Mobile Intel[®] Pentium[®] II Processor Specification Update

Release Date: October 2005

Order Number: 243887-049

Figure 2. Workaround Flowchart: SMBALERT#-Driven System

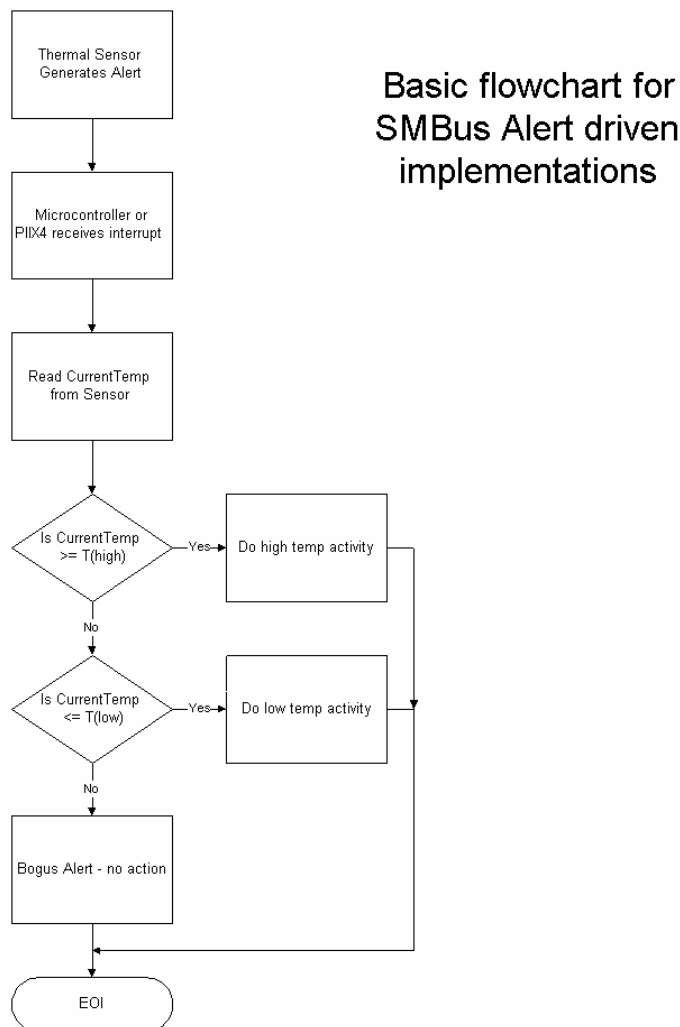
B30. Thermal Sensor May Assert SMBALERT# Incorrectly

Under the conditions described below, the thermal sensor incorrectly generates the SMBALERT# interrupt. All of the following conditions must be met to trigger a false interrupt:

1. Before servicing an interrupt from the thermal sensor, read and compare the processor thermal reading with the threshold limits (T_{HIGH} or T_{LOW}). Figures 2 and 3 provide basic flowcharts for the implementation of this workaround in an interrupt driven system.
2. If the firmware implemented polls the Status Register only, then before taking any action, re-read the temperature register and do a comparison with the alarm threshold limits (T_{HIGH} or T_{LOW}) to determine if the value is actually still within the temperature window.

3. Use a temperature polling scheme to monitor the processor temperature.

Figure 1. TAP Gageable Thread Clarification

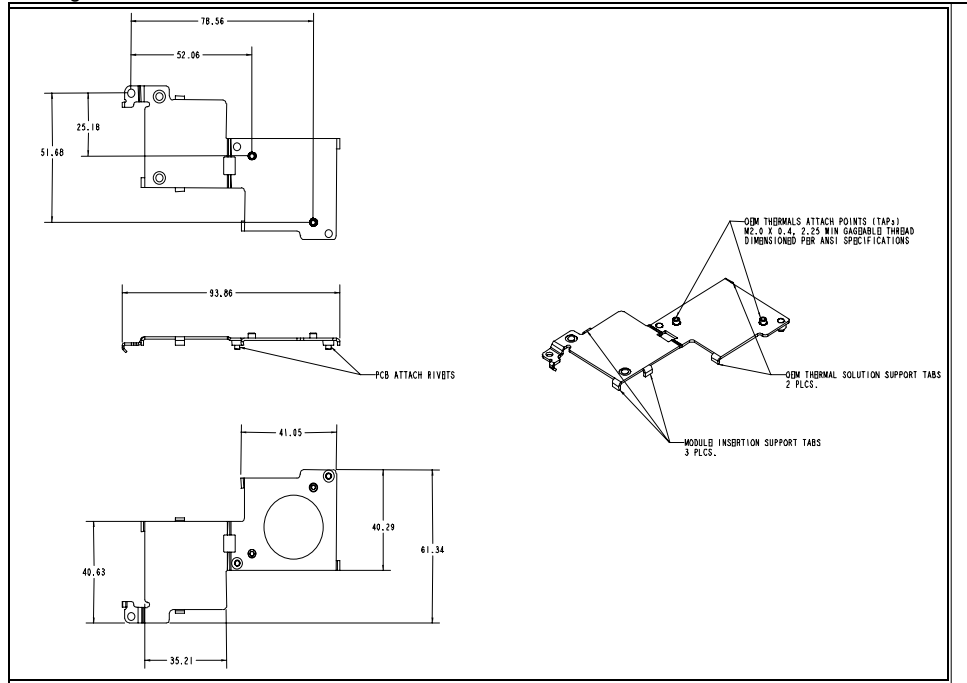
In the *Intel® Pentium® II Processor Mobile Module : Mobile Module Connector 1 (MMC-1)* and the *Intel® Pentium® II Processor Mobile Module : Mobile Module Connector 2 (MMC-2)* datasheets (Order Numbers 243667 and 243668, respectively), the thermal attach point (TAP) gageable thread specification was not clearly identified in Figure 14, of Section 5.2. The following is the TAP clarification:

OEM Thermal Attach Points (TAPs) M2.0 x 0.4, 2.25 min gageable thread dimensioned per ANSI specification.

See Figure 1 below for more information.
